CITY OF KELOWNA

Date: April 15, 2008
File No.: 0710-20
To: City Manager
From: Civic Properties Project Supervisor
Subject: Laurel Packinghouse Structural

Structural Review
of the
Laurel Packinghouse Building
(The Wine Museum)
130-4 Ellis Street, Kelowna

CWMM Consulting Engineers Ltd. was engaged to review the structural assessment report made by *Elbury Dolan Consulting Ltd.* dated 2006-09-08 and provide a second opinion of the recommendations made in that report given the large potential costs of repair. An exhaustive review of the structure is beyond the scope of this assessment, including any analysis required to validate the extent of the upgrading recommendations made by *Elbury Dolan*.

Figure 5 -- Roof after 1983 renovation

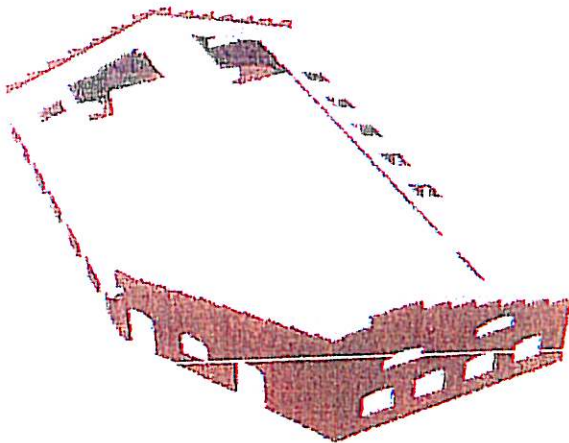
Implementation of the 1983 Woodworth design involved removal of a substantial portion of the original roof surface and replacement of that surface by a new continuous shed dormer on either side of the ridge. This work effectively eliminated the diaphragm function of the original roof surface over the extent where that original roof was removed. Outside the bounds of the new shed roof, two rows of skylights were added, one in each bay between adjacent trusses. These skylights limit the effectiveness of the remaining portion of the original diaphragm. Furthermore, the new shed roof surfaces cannot be said to act as an effective roof diaphragm, because they do not connect with any wall element that might act as a shearwall. That is, the 'outside' wall at the extremity of each shed roof is perforated by a continuous strip of fenestration, and no wall exists beneath the intersection of the 1983 shed roof surface and the original roof surface.

Figure 6 -- Unconnected 2nd floor diaphragm

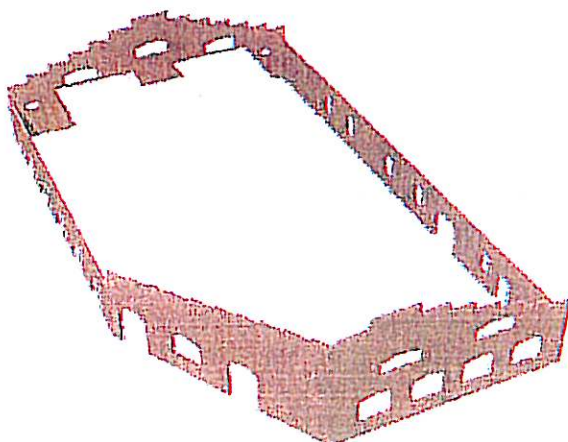
The second floor added in 1983 cannot be said to act as a diaphragm because it does not meet or connect with any wall element below. Also, given that the second floor is discontinuous across the width of the building (i.e.: the centre corridor is higher than the floor on either side), diaphragm action is further compromised.

Considering lateral loads in the east-west direction, we recommend the addition of such blocking, strapping and hold-downs as are required to ensure that the roof and second floor diaphragms act as a unit. Once this is accomplished, it is necessary only to transfer lateral loads from the underside of the second floor to the north and south side masonry walls. This may be accomplished by the addition of steel rod bracing at each of six locations, installed at the elevation of the truss bottom chords, as shown on the bottom half of Figure 8. The two north-south oriented shaded areas (i.e.: one between grid lines "E" & "F" and one between "I" & "K") are intended to denote two discrete diaphragms, each of which includes three X-braced bays and two areas of existing wood-frame floor. The existing trusses function as continuous chords for each of these diaphragms.

Figure 7

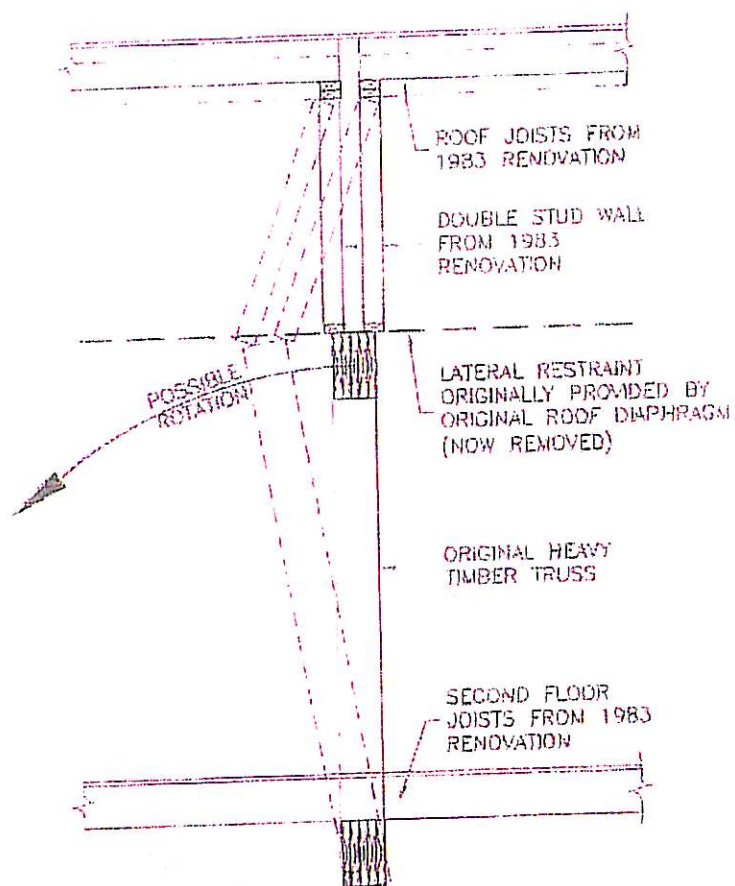
Almost as a by-product of the above discussion, it must be noted that the 1983 renovation removed the means by which lateral support was provided for the top (compression) chord of the original heavy timber trusses. This is a serious omission, since the original roof surface (now removed) was the only structural element employed to prevent buckling of the top chord.

Figure 7, taken from Section 2 on drawing A7 of the 1983 Woodworth drawings, illustrates the failure mechanism associated with buckling of the top chord of a typical heavy timber truss. While such a failure may seem unlikely in light of the passage of more than twenty years since the 1983 renovation, there presently exists nothing to prevent it. The existing detail might actually allow top-chord buckling of one truss while adjacent trusses remain unaffected (i.e.: adjacent trusses contribute no lateral restraint). Thus, local buckling failure of an individual truss might conceivably occur under the influence of a heavy snow load on the roof, even if the overall snow load on the roof were small. While such a contingency might appear remote, the means to prevent it does not exist at present.

In addition to these lateral-load-resisting systems, and with reference to Figure 7, we recommend that a steel brace be added to each side of the peak of each heavy timber truss, continuous between and attached to each of the bottom chord of the truss and the new (1983) high roof.

Figure 8

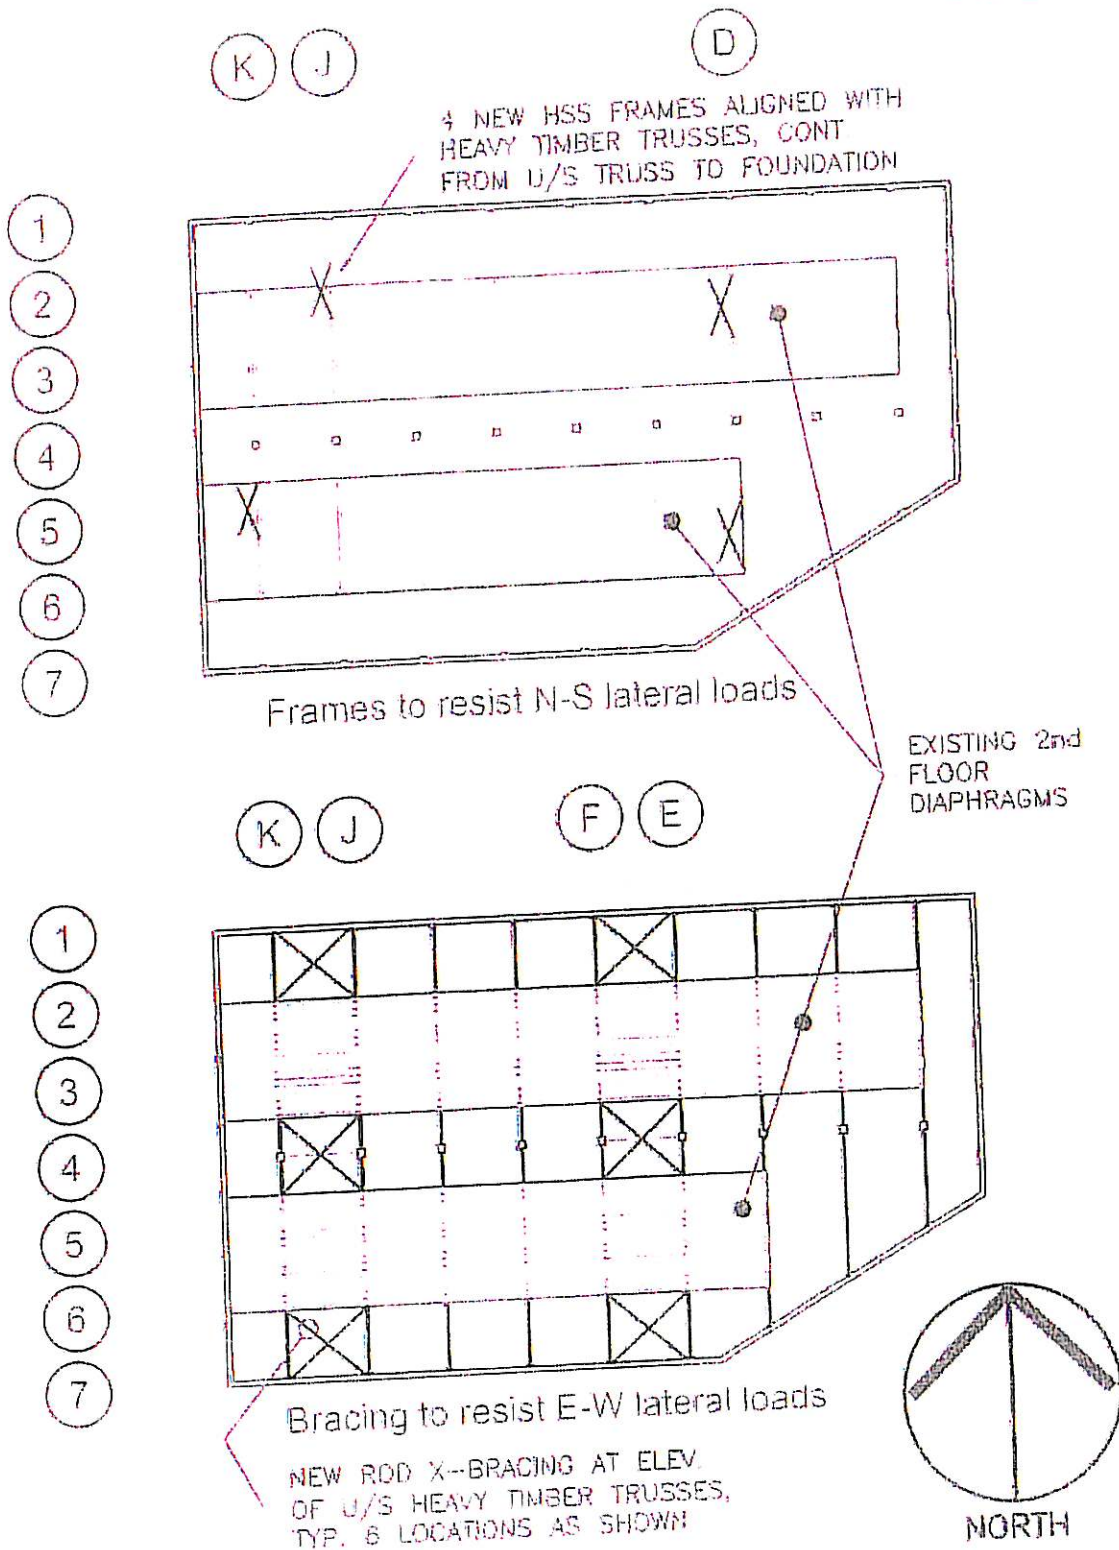
Considering lateral loads in the north-south direction, we recommend that four discrete steel frames be installed, each to be exactly aligned with an existing heavy timber truss, as noted on the top half of Figure 8. Given that the existing trusses ensure that the roof and second floor structures act as a unit under the influence of N-S oriented loads, each new steel frame may terminate at the underside of the existing truss. New foundations are required for each of these four frames, each new foundation to incorporate existing column footings. Two of the four frame locations shown on Figure 8 exactly coincide with existing main-to-second floor partition walls, and will not affect existing museum operations. The frame on grid line "D" between grids "2" and "3" is nearly aligned with an existing wall; a slight change in the wall will be necessary to hide this frame. The fourth frame, on grid line "K", will be exposed, but coincides with the east side of a ramp between the concourse and gallery levels and will not interfere with museum operations. We recommend that the first three frames be fabricated from HSS steel tubes, to facilitate their being incorporated into walls. In order to more closely match the industrial look of the existing building, the fourth frame may be fabricated of W-shape (I-beam) columns and beams, with rod X-bracing members.
